TENDER ADDENDUM

Project:	UHN Interventional Fluoroscopy Replacement University Hospital of Northern British Columbia 1475 Edmonton Street, Prince George, BC V2M 1S2	Tender Addendum #:	02
		DCTYA Project #:	2009
		NHA Project #:	N662050005
		Issued By:	Douglas Cheung
To:	All Bidders	Issue Date:	Feb 26, 2021
Copies To:	Leah Joseph / Northern Health Authority

STRUCTURAL ADDENDUM No. 2

Project: UHN Fluoroscopy Replacement **File:** 11815
Architect: DCYT Architecture, Douglas Cheung **Date:** February 26, 2021

S11

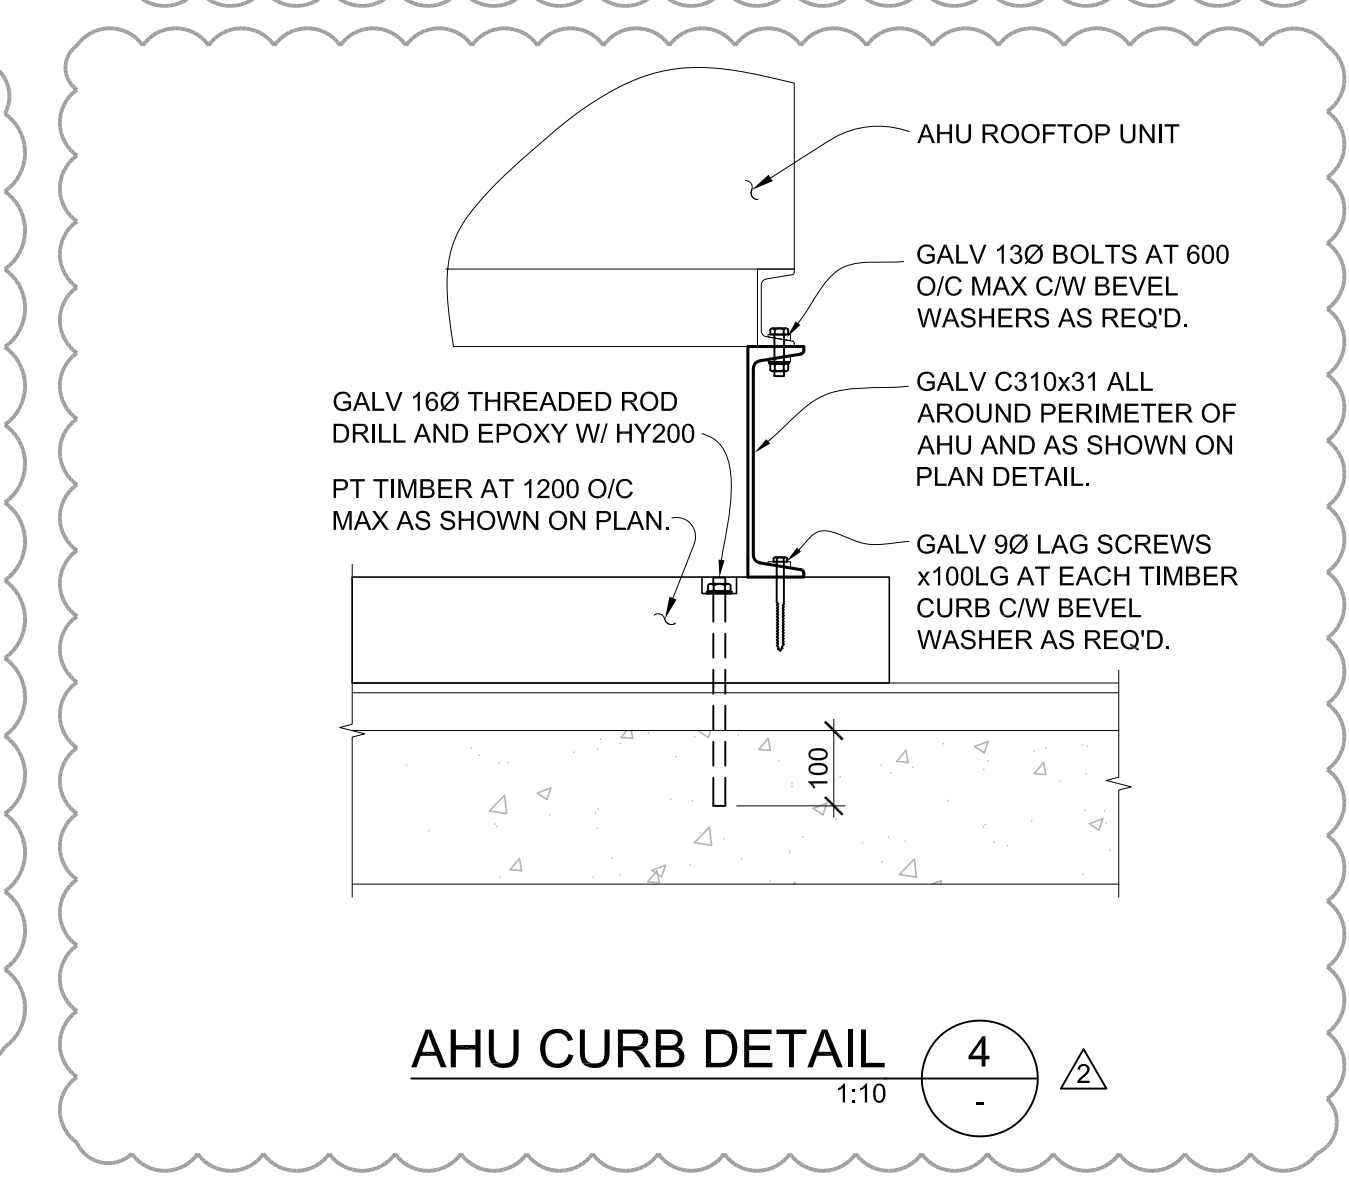
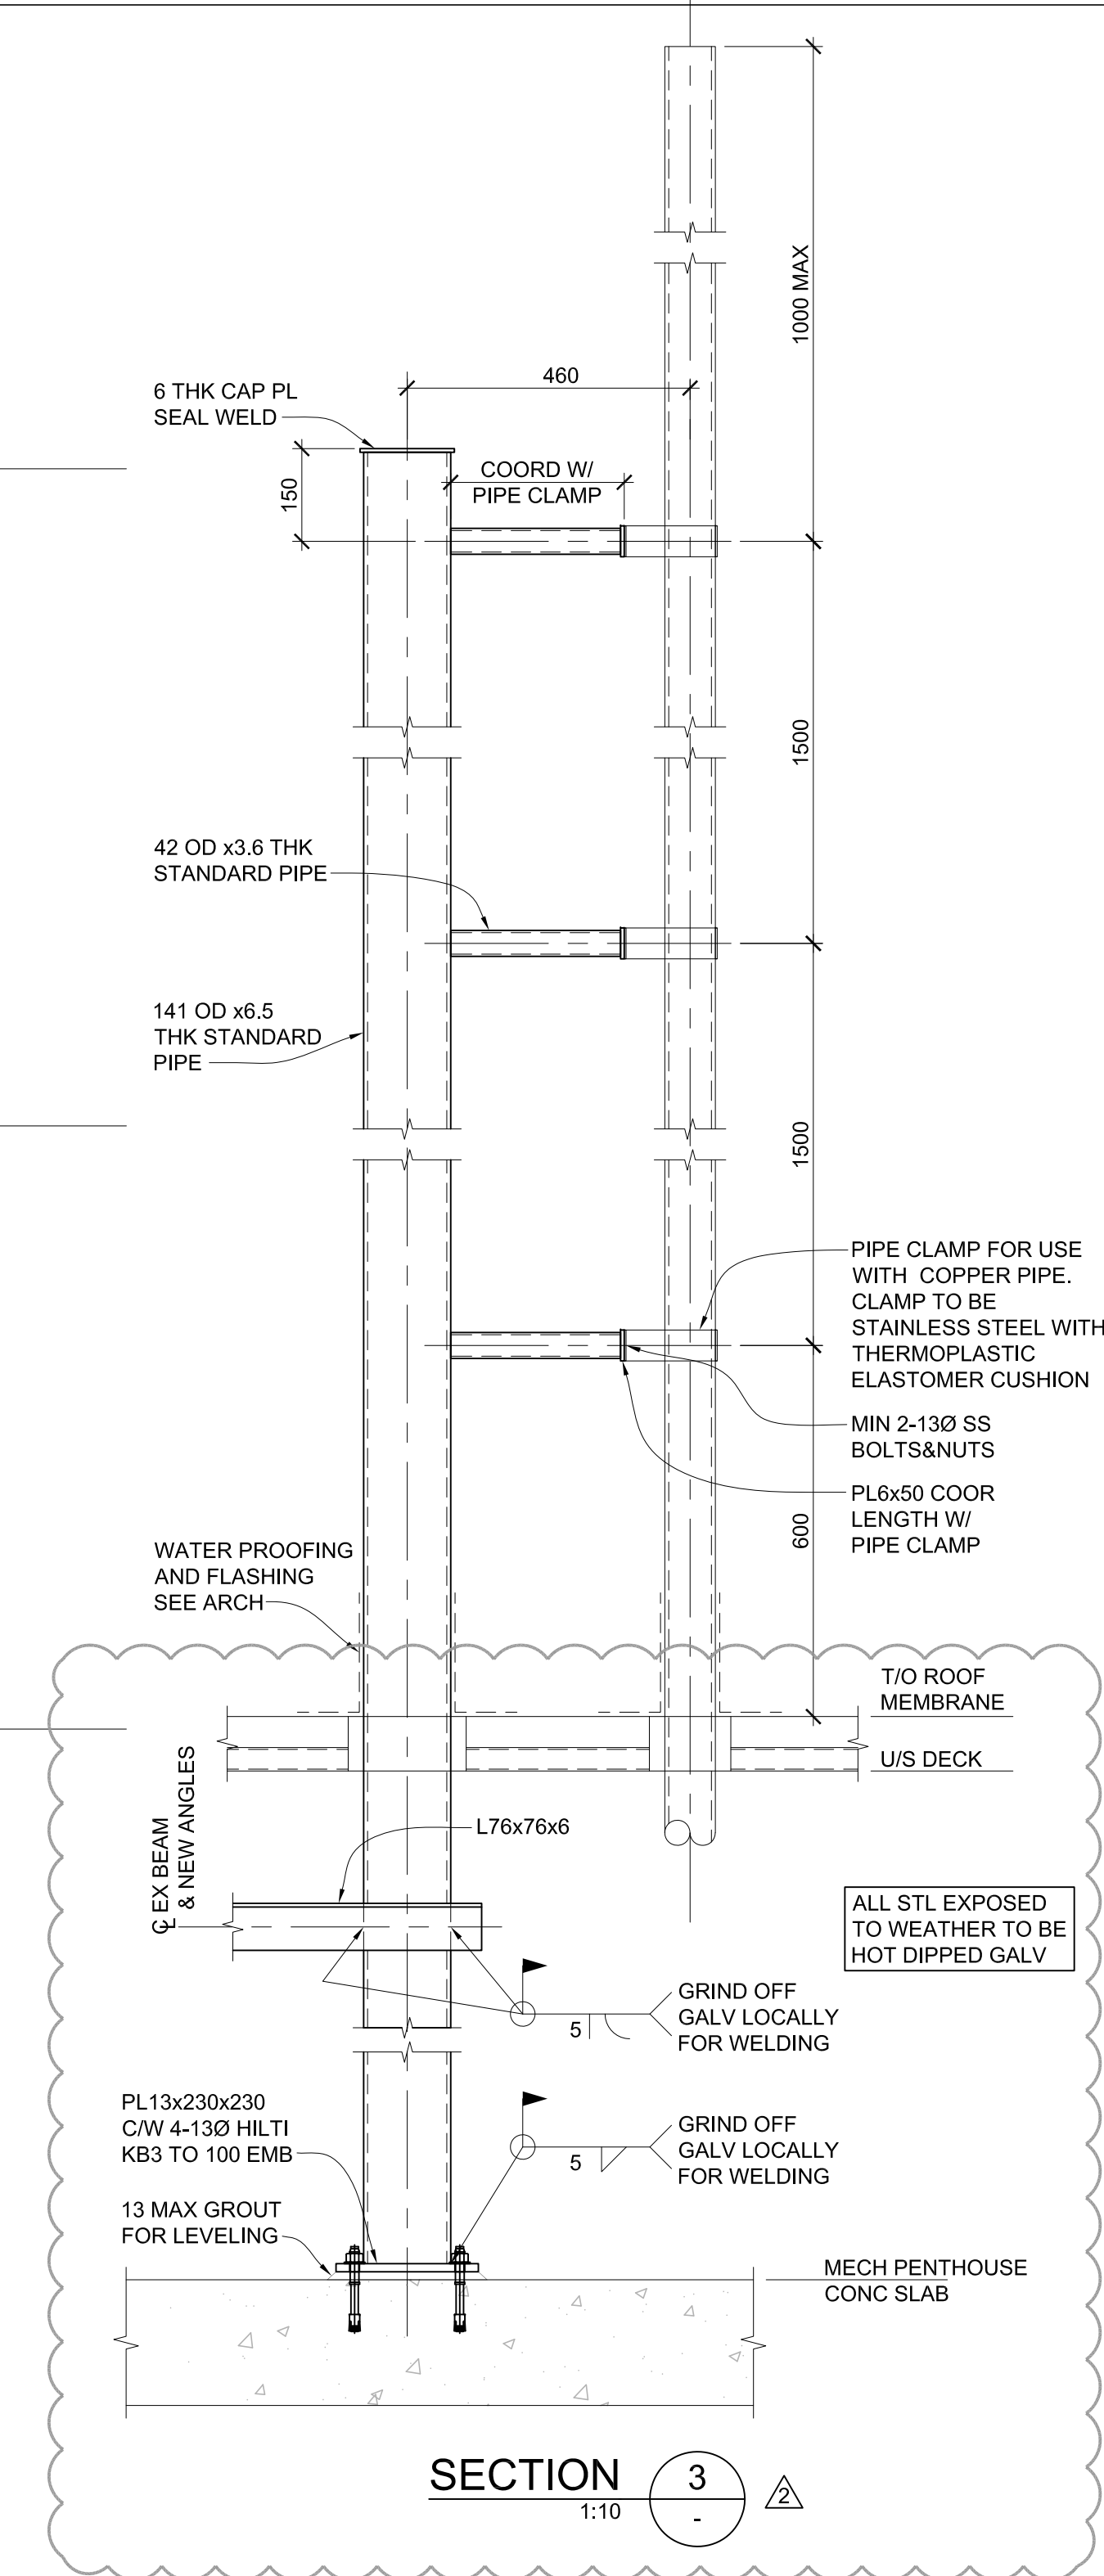
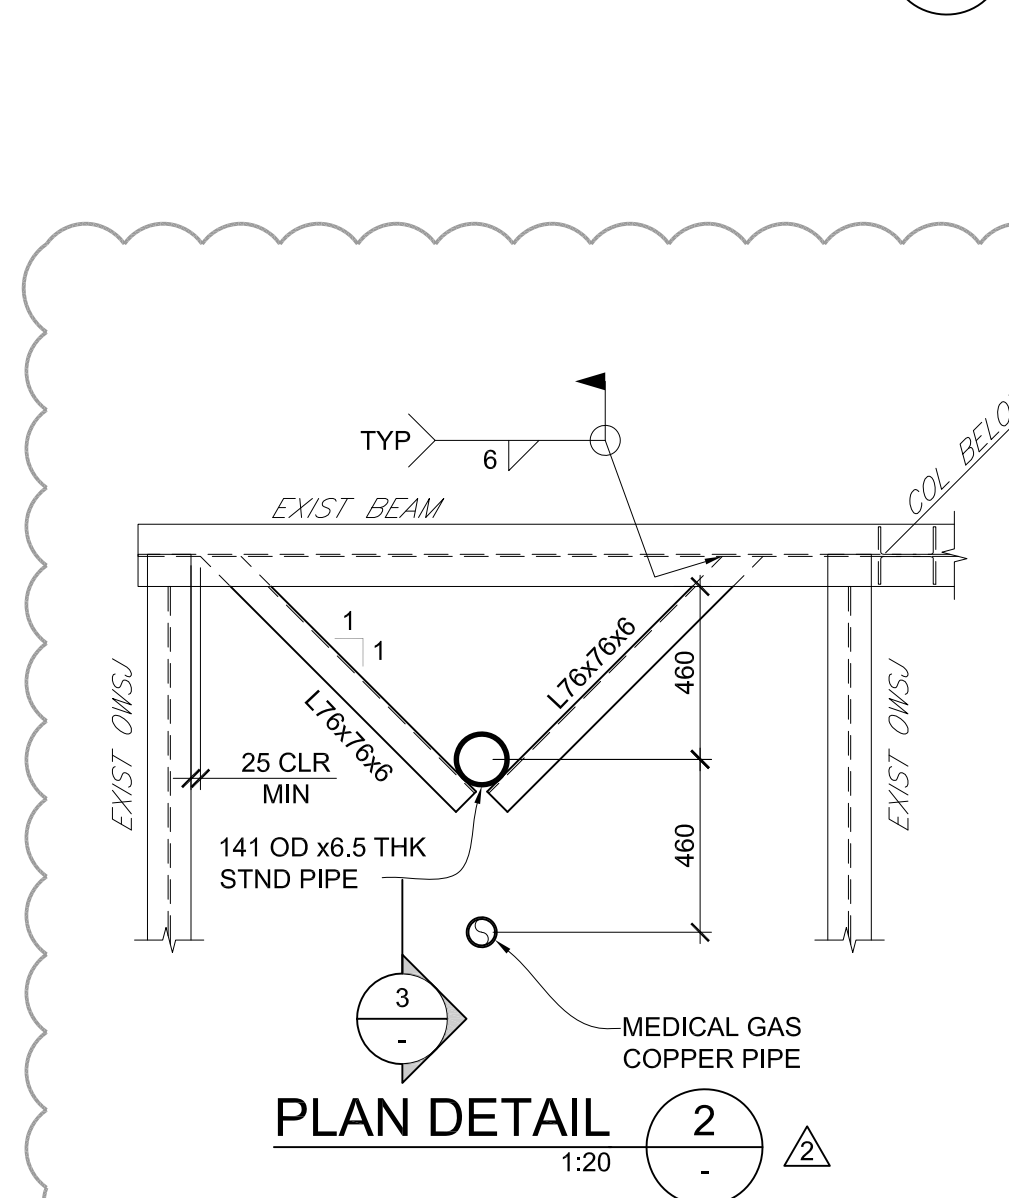
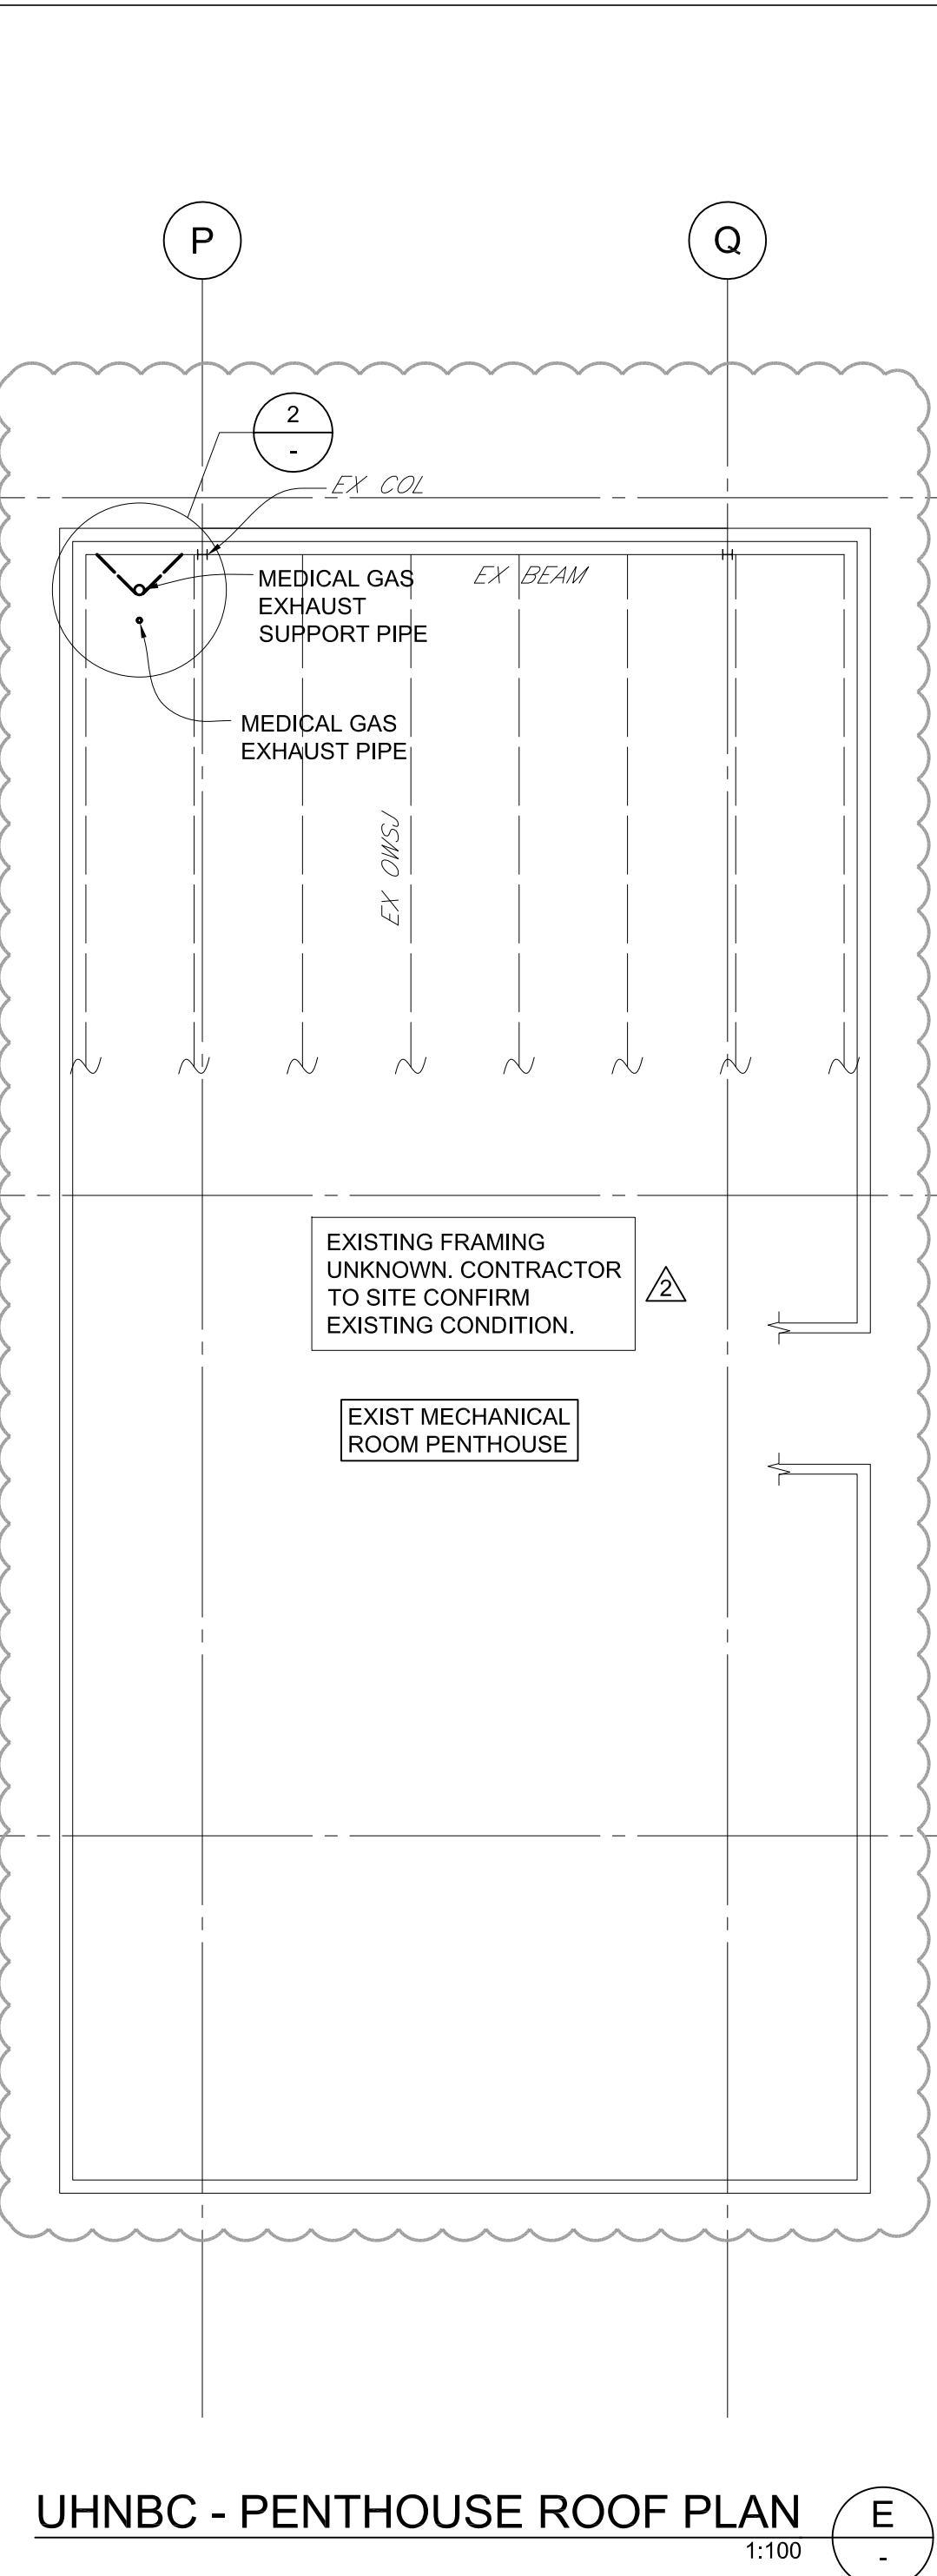
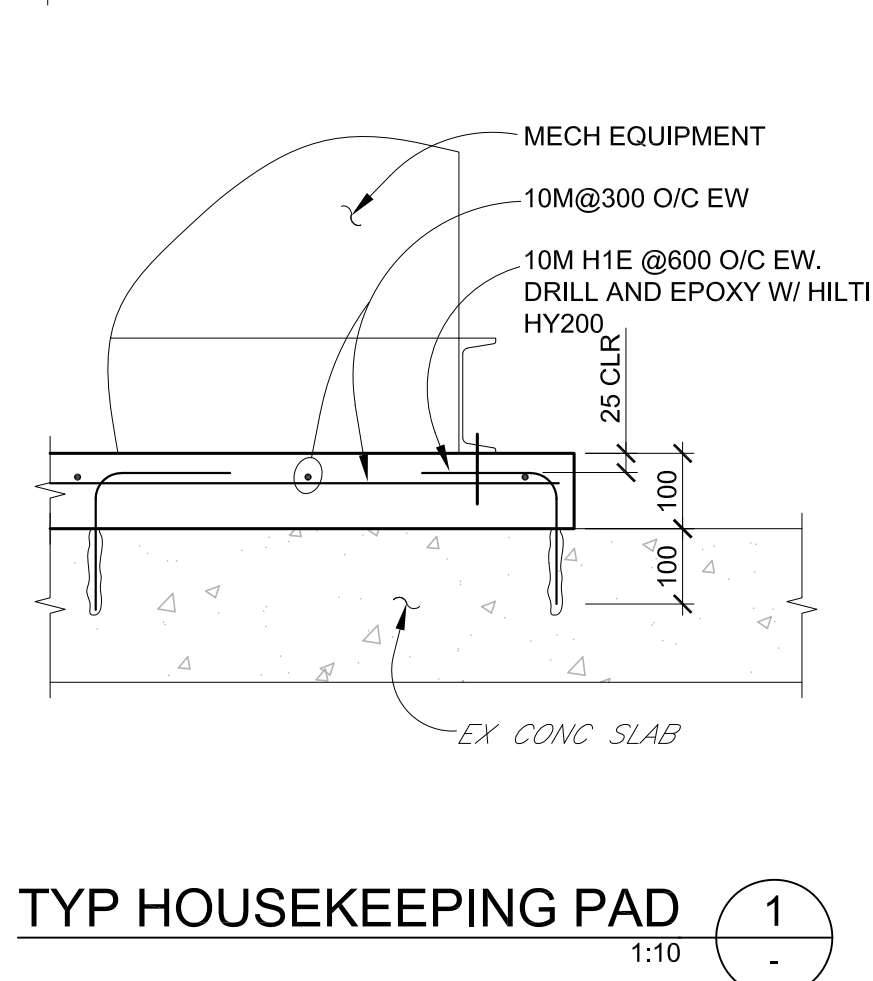
REVISIONS TO DRAWINGS**ITEM DWG. REVISION TO DRAWING / SPECIFICATION****1 S11 PHASE 1 - INTER FLUORO - ROOF & PENTHOUSE PLANS & SECTIONS**

- 1 On roof plan, change continuous AHU timber curb to timber curbs spaced at 1200mm on center and adjust notes to match as shown on S11 attached.
- 2 Add detail F and section 4 to show extent of pressure treated timber curbs and structural steel C310x31 curb around perimeter of AHU unit. All steel and fasteners to be hot dip galvanized as noted on details.
- 3 On penthouse roof plan, adjust existing roof framing based on site photos as existing framing does not match existing drawings. Framing is to be confirmed by the contractor on site prior to fabrication of medical gas exhaust support structure. Adjust support structure location to suit site conditions as shown on S11 attached.
- 4 Detail 2 and 3 revised to suit site conditions. Change vertical steel pipe size to 141mm outside diameter and extend to penthouse floor slab.
